SOUTH HOLLAND DISTRICT COUNCIL

Planning Permission

Reference: H13/0267/93 Received:22-MAR-93 Type:FULL

Description: Alterations and extensions

project no.	*drawing no.*
112[redacted]0	AB/1

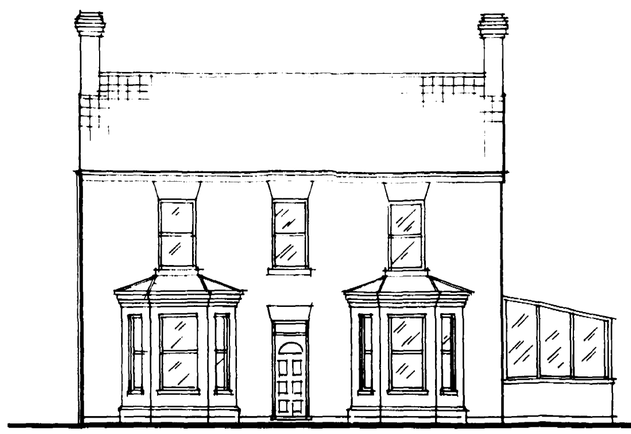
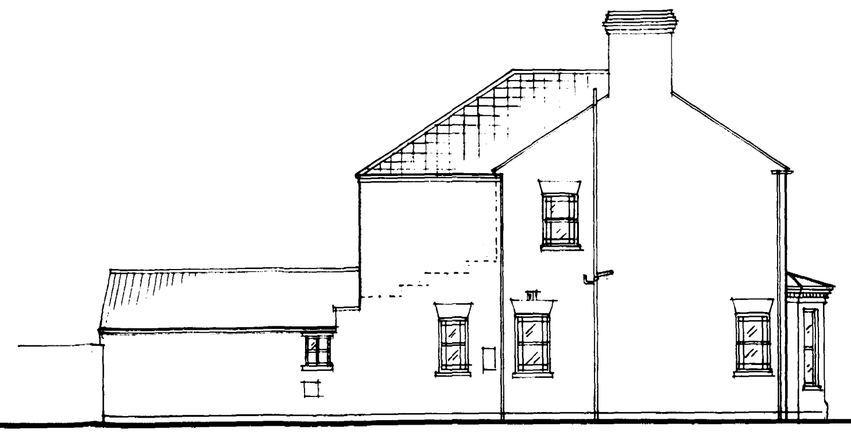
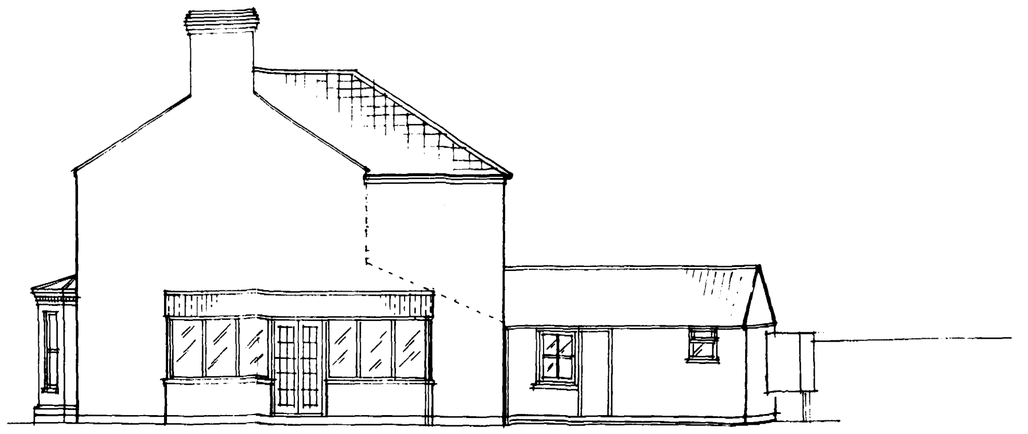
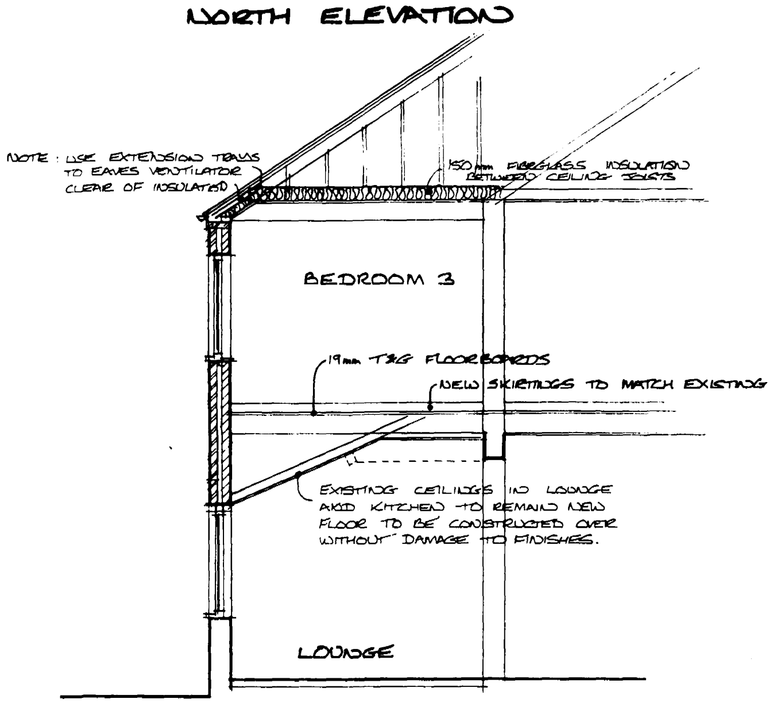
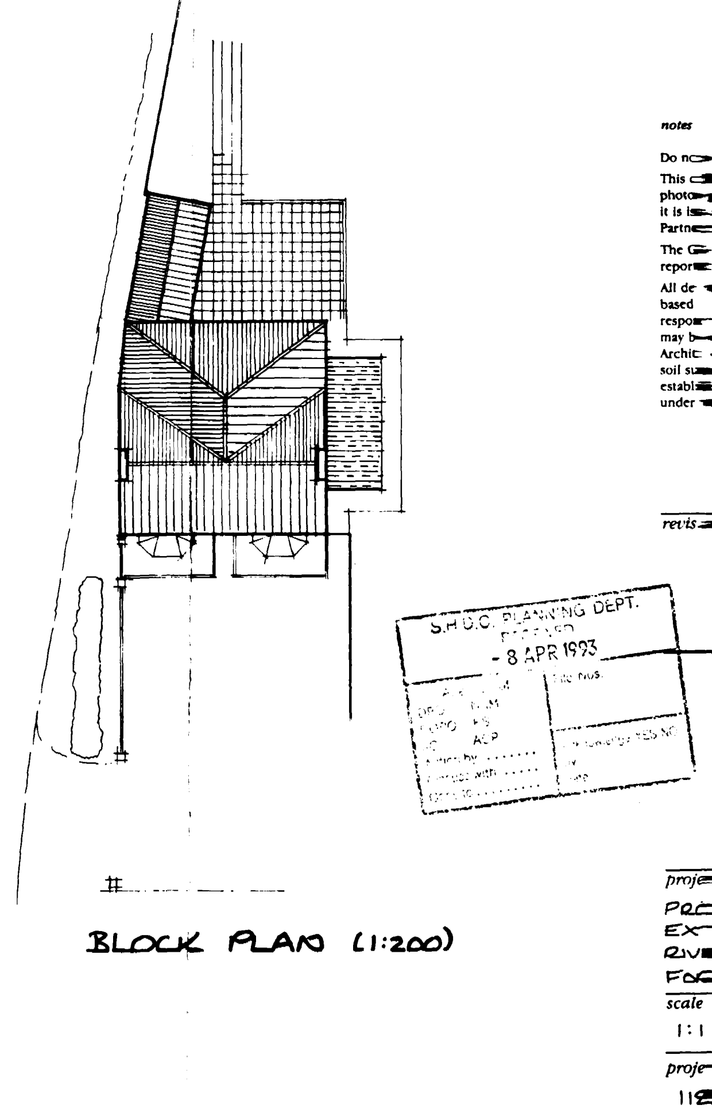
I would advise you that strong reservations are felt about the proposed fenestration; the existing fenestration of the building has a vertical emphasis and this emphasis should be echoed or reinforced in the proposed extension.

I would be obliged, therefore, if the windows of the proposed extension could be redesigned to give a much more vertical emphasis.

I would also add that the roof of the proposed extension should have a slate cladding to match the roof of the main building. I acknowledge the existing extension has a difference cladding and that the tiles of that roof will be reused. However, the proposed roof will be much more prominent and, therefore, I consider an appropriate slate cladding is called for.

Finally, could you please specify what facing brick your client has in mind as the existing red brick may not be easy to secure a match with in terms of colour and texture.

Following our meeting with yourselves last Friday and our subsequent discussions with the client we enclose our revised drawing 1180 AB/1 (1) with the following revision.

1. The windows have been redesigned to give a more vertical emphasis, re-using the existing windows.

2. The proposed extension will now have a slate cladding to match the roof of the main house.

We would therefore be grateful if you would substitute the revised drawing for the originally submitted drawings AB/1 and AK/6.
